App. No. 10/501,744  
Amendment dated November 30, 2005  
Reply to Office action of August 31, 2005

**Amendments to the Drawings:**

Appl. No. 10/501,744  
Amtd. Dated Nov. 30, 2005  
Reply to Office action of August 31, 2005  
Annotated Sheet Showing Changes

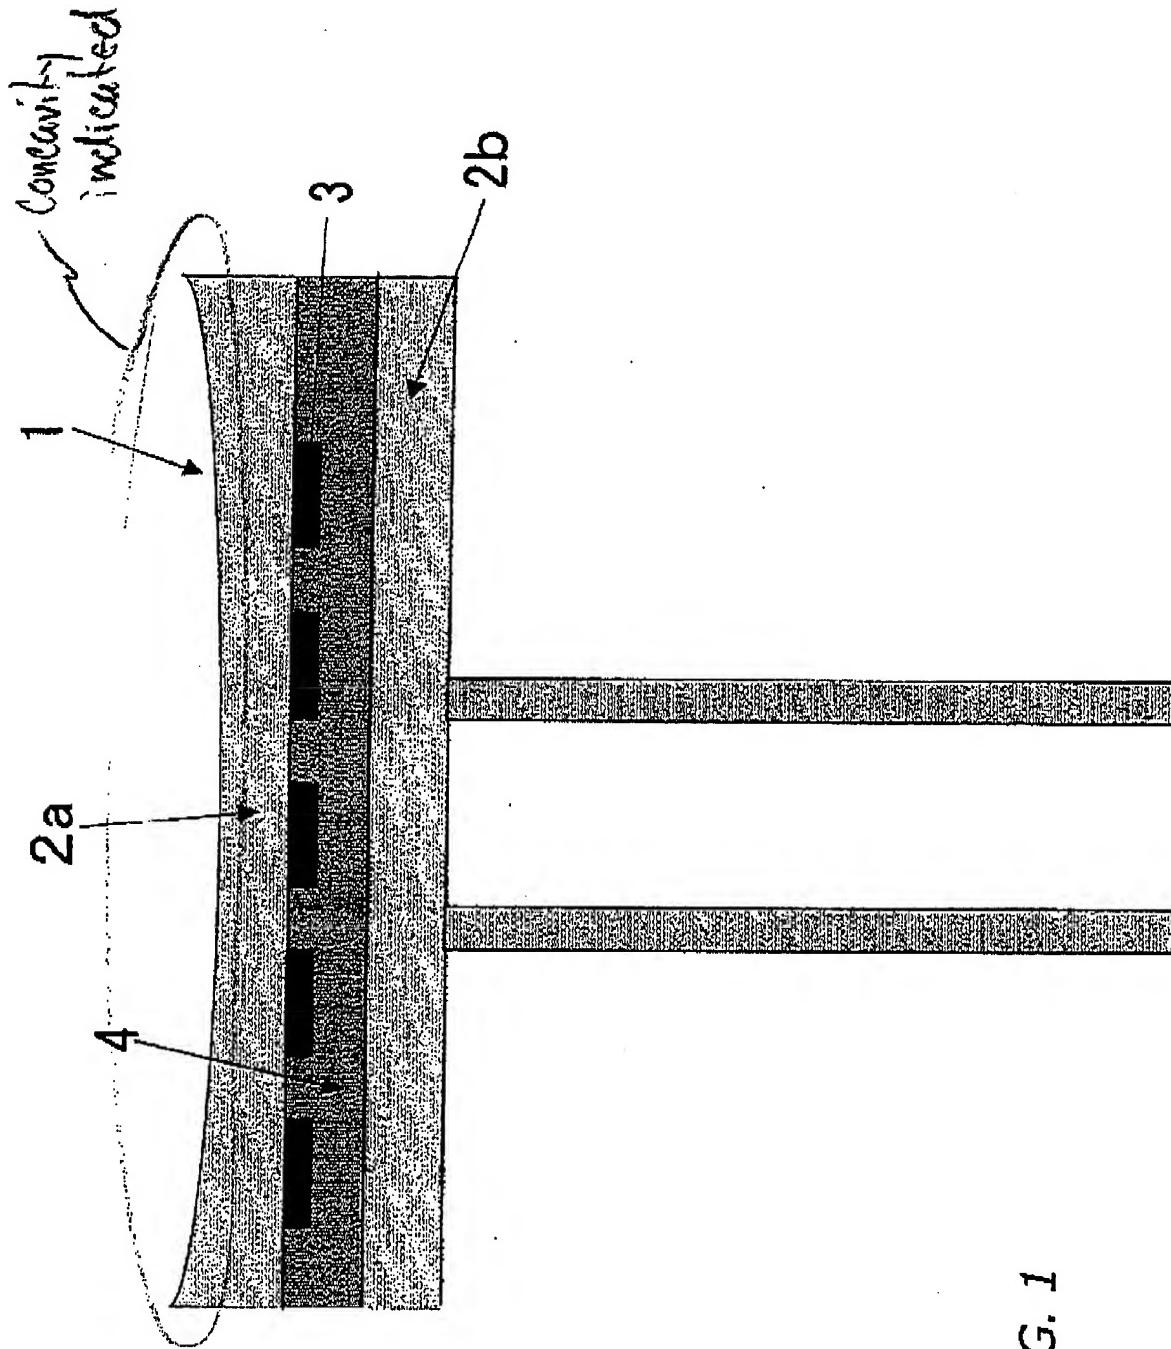
In Figs. 1 and 2, the upper surfaces of the respective susceptors 1 and 11 have been redrawn to represent the concavity therein.

2. The drawings were objected to under 37 CFR 1.83(a). In particular, the Examiner states: "The concavity in claim 1 must be shown or the feature(s) canceled from the claim(s)."

3. Applicants submit corrected drawing sheets herewith in compliance with 37 CFR 1.121(d). Applicants refer the Examiner to new drawing sheets 1/2 and 2/2 including amended Figs. 1 and 2, respectively. Figs. 1 and 2 have been amended to show the concavity of the wafer carrying face and the shaft recited in amended claim 1. Support for these drawing amendments may be found, for example, in Embodiment 1 on pages 6 through 9 of the original specification such that no new matter has been entered. The concavity is supported, for example, by the "warpage" values given in Table 1 (page 9). The concavity is also supported by original claim 1 as well as by numerous other locations in the original specification. The shaft is supported, for example, by the "pipe-shaped support members" disclosed on page 8.
